dul.					
LAYOUT SINGT					
INSP 3					
ISSUE DATE:	7/28/08 P	ERM	IT P 523	P 523027	
APPROVAL DATE:	10/6/05	X ID #033	A 515281-	С	
	ON-SITE SEWA HOWARD COUN	AGE DIS	POSAL SYSTEM TH DEPARTMENT ENTAL HEALTH		
Fogles Septic Clean, Inc		IS P	ERMITTED TO INSTALL ALTER		
ADDRESS: 580 Obrecht Road		14 8 600	PHONE NUMBER: 410-795-56	70	
SUBDIVISION: Crist Property		LOT NUMBER: 4			
ADDRESS: 13965	Burntwoods Road	PRO	PERTY OWNER: Jason & Katie Mackey		
SEPTIC TANK CAPACITY (GALLONS):		1250	OUTLET BAFFLE FILTER REQUIRED		
PUMP CHAMBER CAPACITY (GALLONS):		1250	COMPARTMENTED TANK REQUIRED	TMENTED TANK REQUIRED	
NUMBER OF BEDRO	OOMS:	4			
SQUARE FEET PER BEDROOM:		180			
LINEAR FEET OF TRENCH REQUIRED:		150	HOUSE SERVED BY PUBLIC WATER		
TRENCHES:	Trench to be 3.0 feet wide. Inlet 4.0 feet below original grade. Bottom maximum depth 6.0 feet below original grade. Effective area begins at 4.0 feet below original grade. 2.0 feet of stone below distribution pipe.

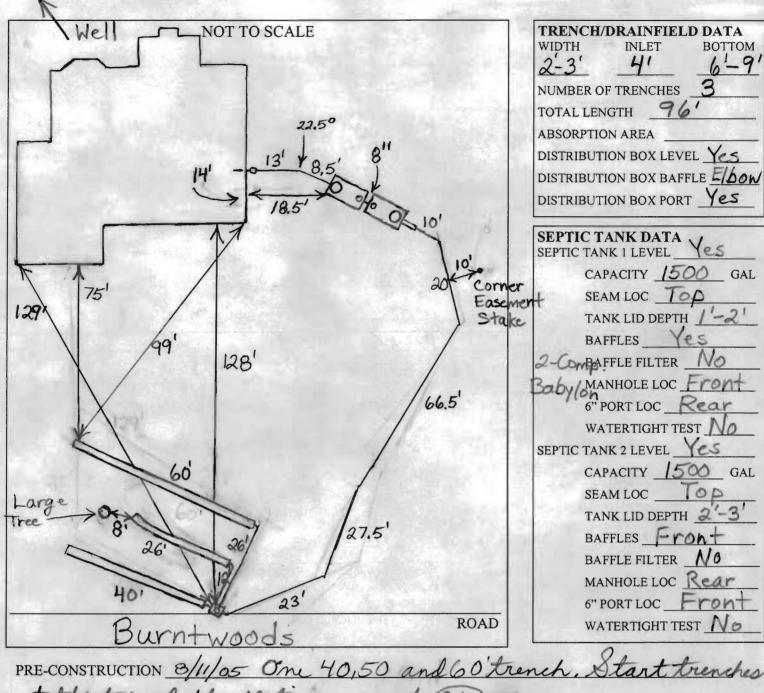
PRE-CONSTRUCTION 8/1/05 One 40,50 and 60 trench. Start trenches at the top of the Septic easement. GAD #8
INSTALLATION 8/12/05 Installer didn't lay out trenches correctly and started trying to curve second trench around large tree. Foldhim to stop trench where it started going off contour. Made bottom 60' trench 2' wide and 9' deep to more than make up for lost area. Soil looped good. Need fump and alarm test and house connection (BB) 10/5/POA

No water in tunk (P) 10/6/05 Pump and alarm working. BB)
